International Code Council

**ICC 500-2023 edition
Committee Action Report on the
Public Input Agenda
based on input received
on 2020 edition of the
ICC 500 Standard
6-15-2023**

**For February, 2023
Meeting – Teleconference**

Figure 306.4.1.1
Door clearance

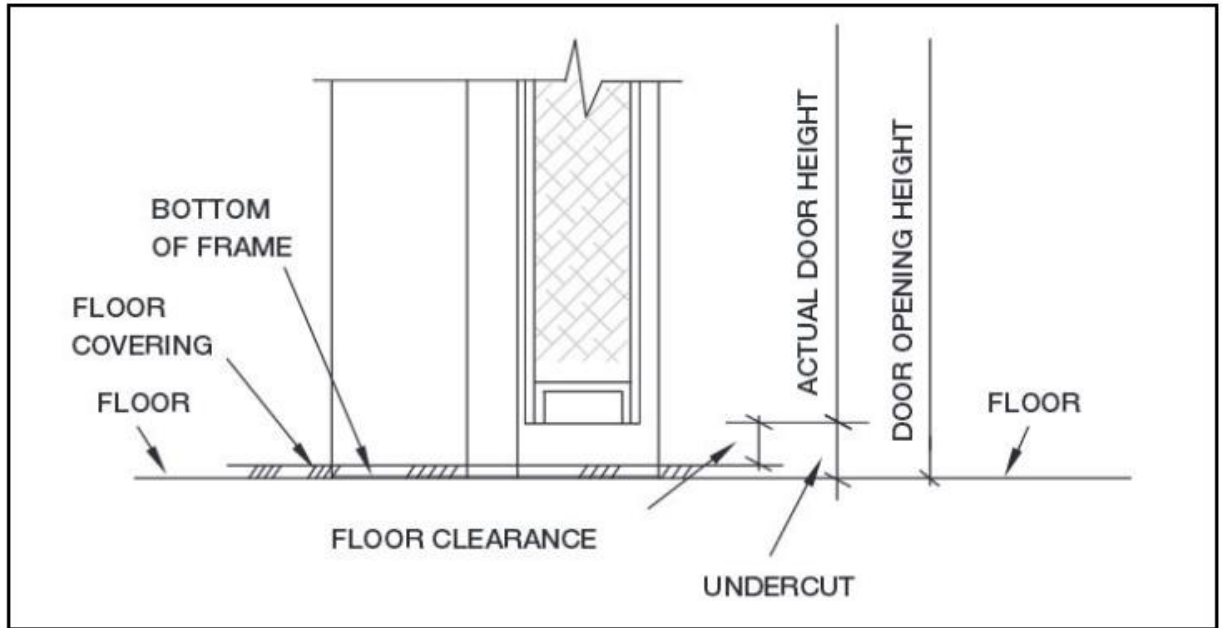
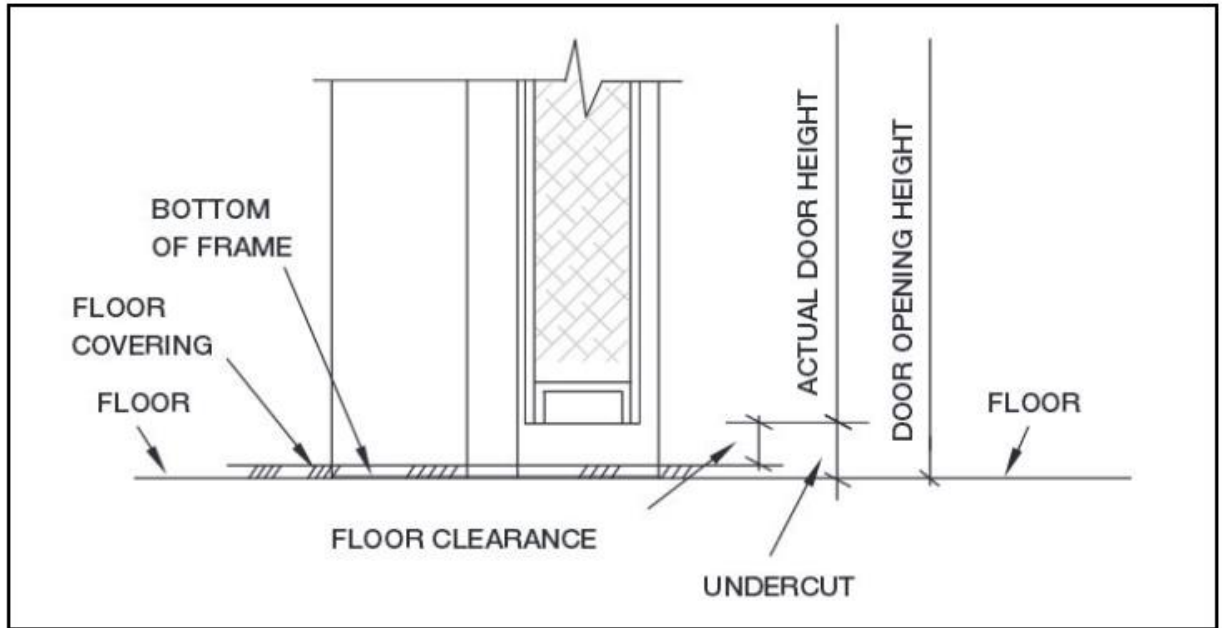
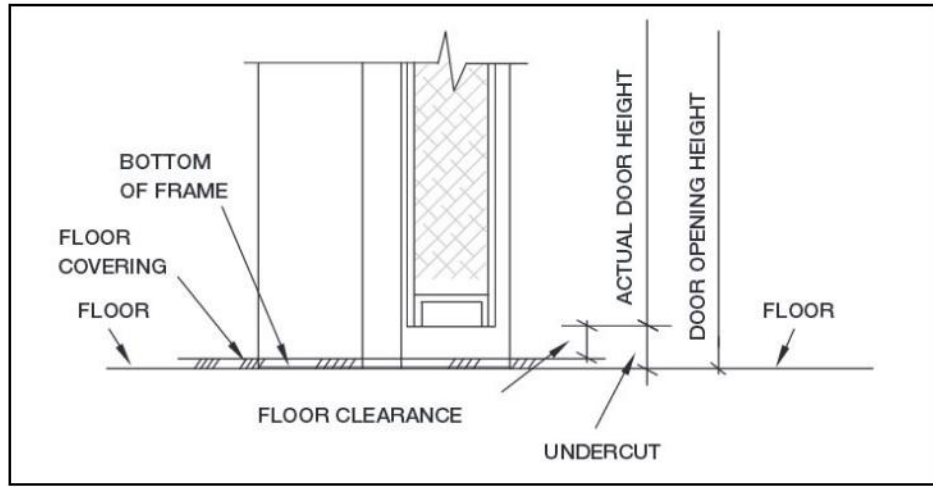
Additional criteria may be needed for the bottom edge of sectional or rolling doors later, but there is no guidance right now for what that should be. So this proposal is keeping this general for all doors until that is determined.

From NFPA 80 – need new figure similar to this, but add threshold, change verbiage to match text.

306.4.1.1 Door undercut clearance. Floor clearance for door Door assemblies for use in the storm shelter envelope with a threshold at the level of exit discharge shall be limited to a 3/4-inch (19.1 mm) maximum, undercut measured from the top of the threshold or finished floor. (See example in Figure 306.4.1.1).

**FIGURE 803.9.3(1)
MASONRY UNIT WALL ASSEMBLIES AND ROOF ASSEMBLIES**

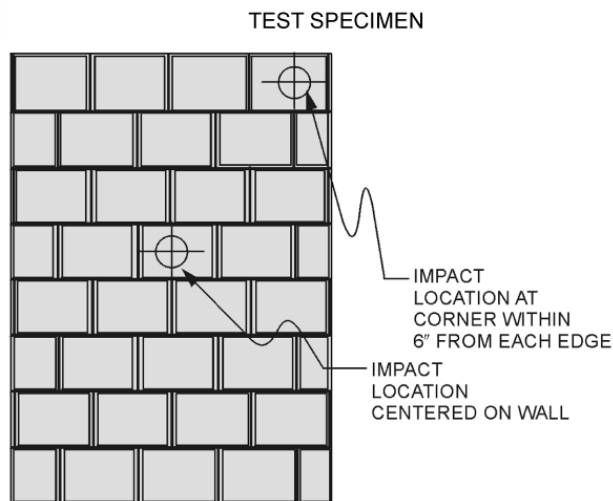
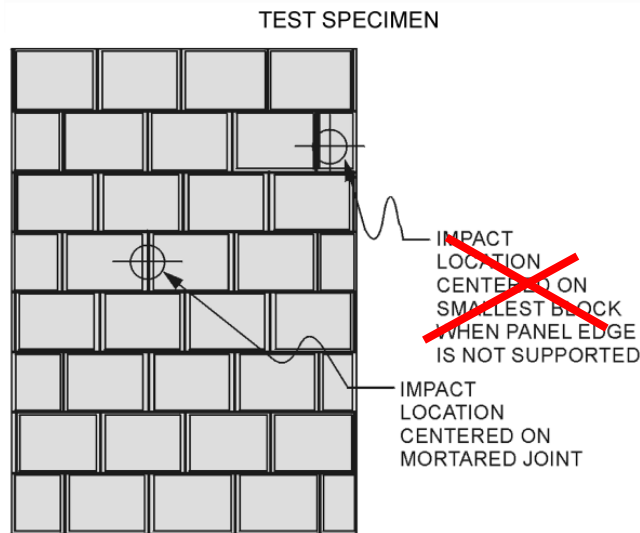
Reason: The smallest block impact does not appear in the text requirements. As the figures are informational only, the figure should be revised to match the text requirements.

803.9.3 Masonry unit wall assemblies and roof assemblies. Sections of wall assemblies and roof assemblies constructed of masonry units shall be impacted in the center of the section, and at one interface corner or joint as detailed in Figure 803.9.3(1). Mortared joints shall be impacted directly on the interface joints as detailed in Figure 803.9.3(2).

FIGURE 803.9.4.3 SECTIONAL DOOR ASSEMBLIES

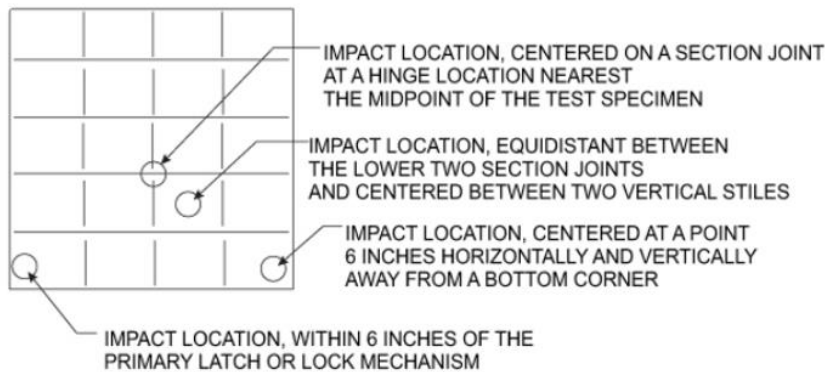
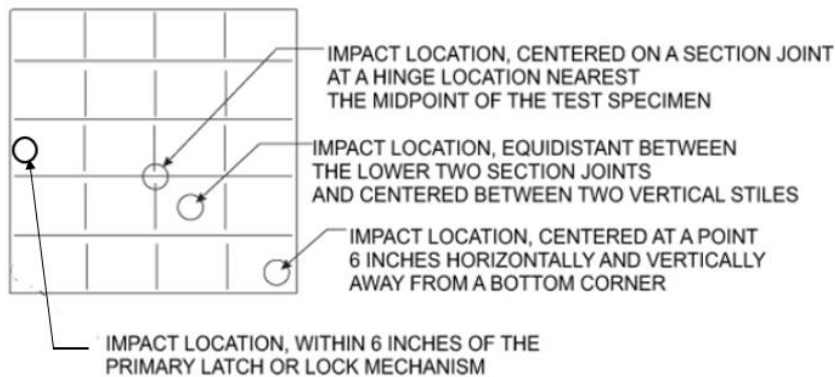
Reason: Cleanup and clarity of text to align with Figure. There should not be variation in the text between the section language and the figure.

803.9.4.3 Sectional door assemblies. For sectional door assemblies, the door shall be impacted centered on a section joint at a hinge location nearest the midpoint of the test specimen, equidistant between the lower two section joints and centered between two vertical stiles, centered at a point 6 inches horizontally and vertically away from a at one bottom corner, and within 6 inches (152 mm) of the primary latch or lock mechanism as shown. See example in Figure 803.9.4.3.

FIGURE 803.9.5(1)
WINDOW ASSEMBLIES AND OTHER GLAZED OPENINGS

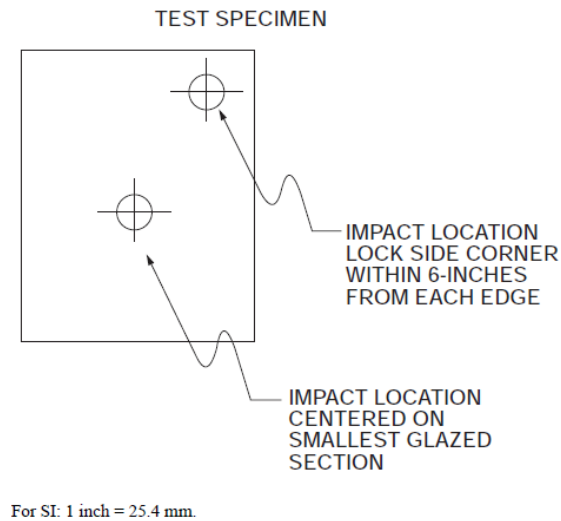
Reason: Cleanup and clarity of text to align with Figure. There should not be variation in the text between the section language and the figure.

Modify figure 803.9.5(1) to include 'one interface corner' in note

Figure 803.9.5(1) 803.9.5.1
WINDOW ASSEMBLIES AND OTHER GLAZED OPENINGS
(Note: Change 'lock' to 'lock/latch' in note)

FIGURE 803.9.6(1)
LOUVER ASSEMBLIES

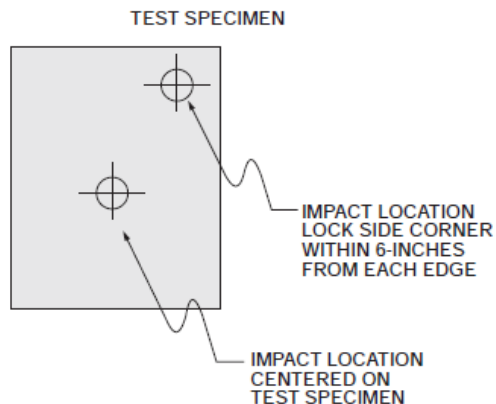
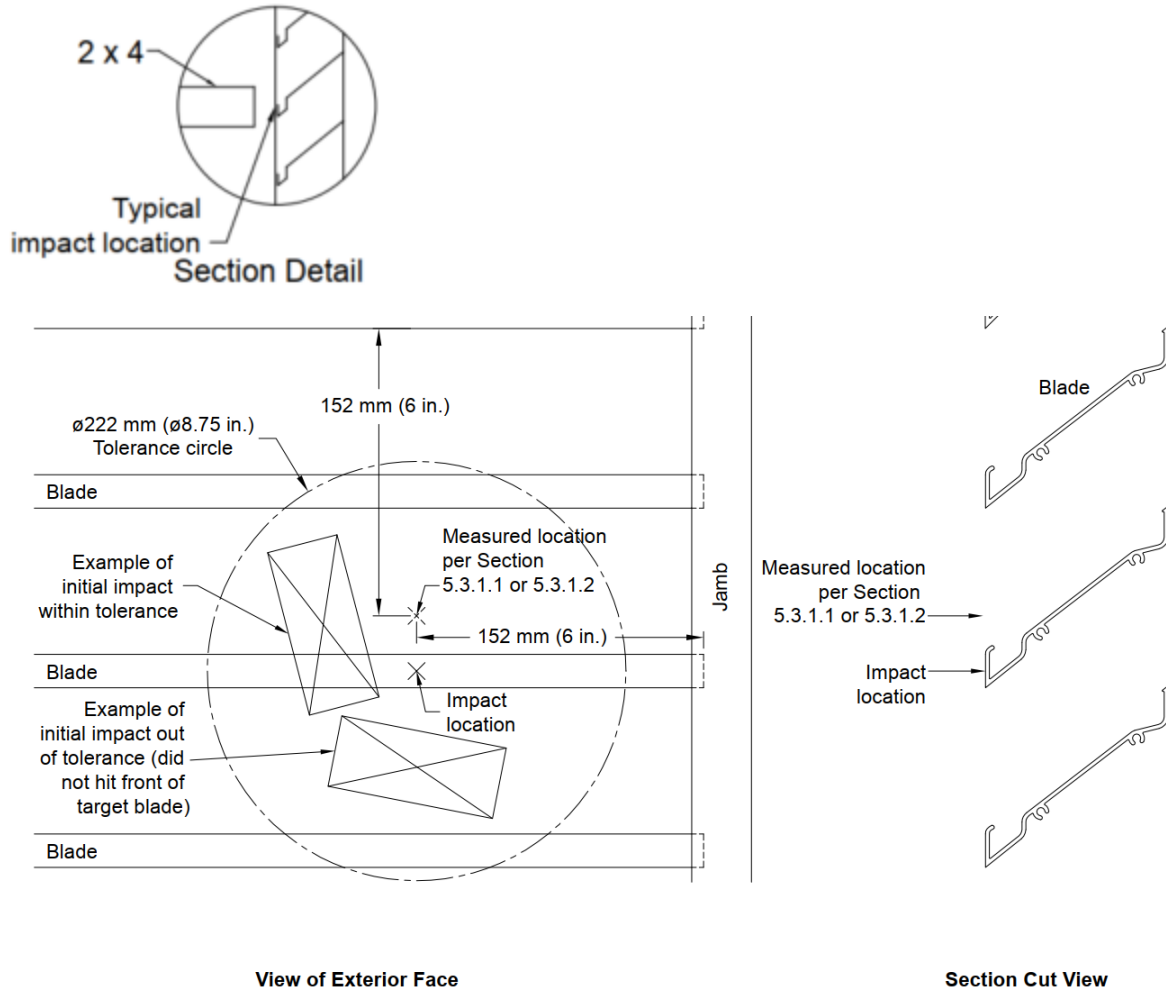
Reason: Specifics are needed for louvers.

803.9.6 Louver assemblies. Louver assembly test specimens shall be impacted at the center of the unsupported span on each unique louver section, and at one interface corner of each unique louver section. See example in Figure 803.9.6(1). The exterior edge of the louver blade shall be impacted by a portion of the leading face of the test missile. See example in Figure 803.9.6(2).

FIGURE 803.9.7.1
ALCOVE OR BAFFLED STORM SHELTER ENTRY SYSTEMS FOR WHICH TESTING IS REQUIRED

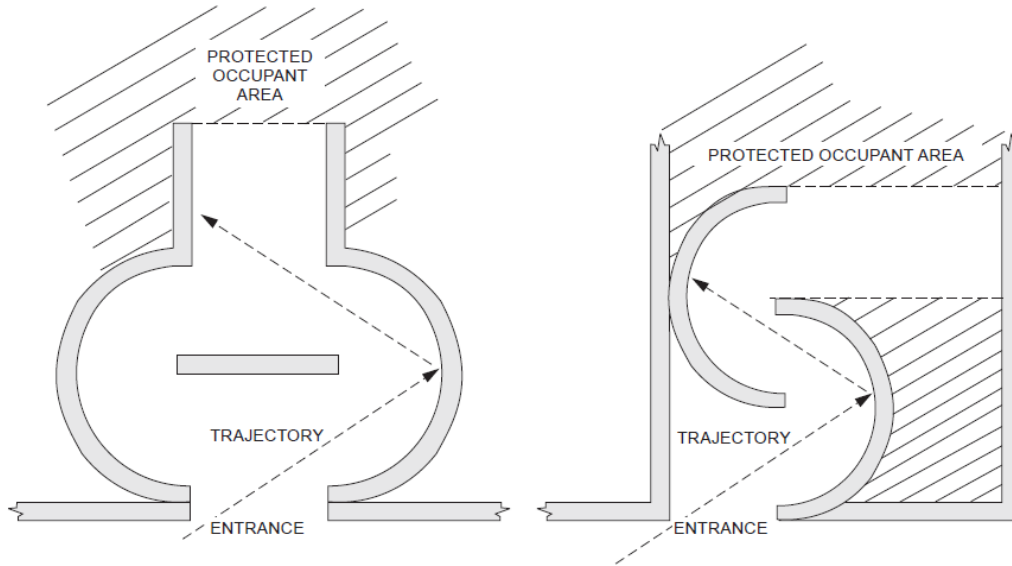
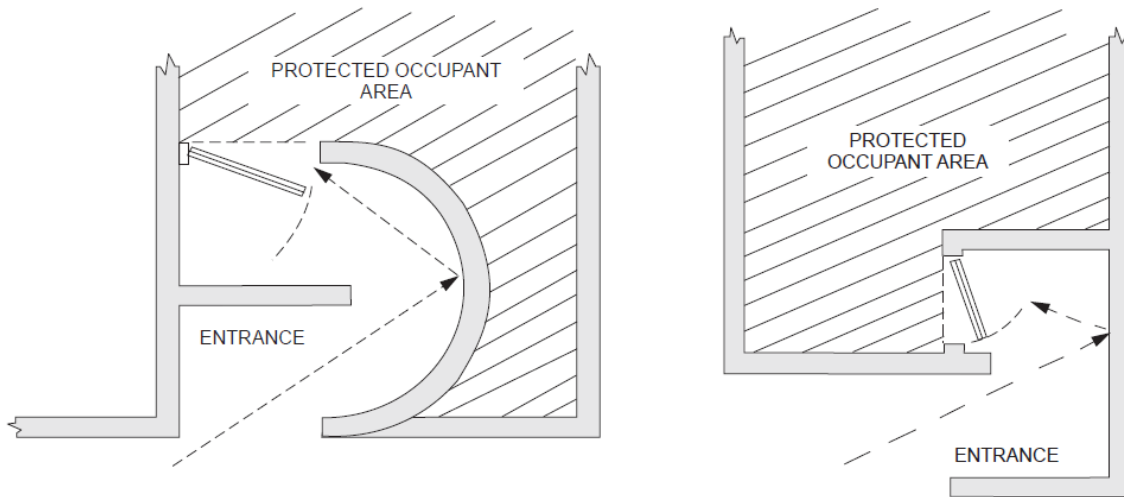
Reason: Figure 803.9.7.1 does not depict a rebound impact on a door, which is the scope of item 2 and Section 803.9.7.2.

Committee Reason: Figure 803.9.7.1 does not depict a rebound impact on a door, which is the scope of item 2 and Section 803.9.7.2.
